Issue List

Toppers Pizza (Manhattan, KS)

Project Issue Information

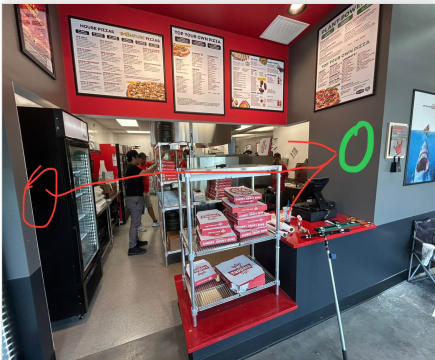
Issue Name : RTU-2 temp sensor location
Description : RTU-2 temp sensor is not at design location. sensor is located next to a refrigerator which may affect the accuracy of sensed temperature. Design location is not recommended either due to proximity to the front window and may be affected by sunlight and cold temperatures near the glass. Recommend relocating sensor to the location circled in green.
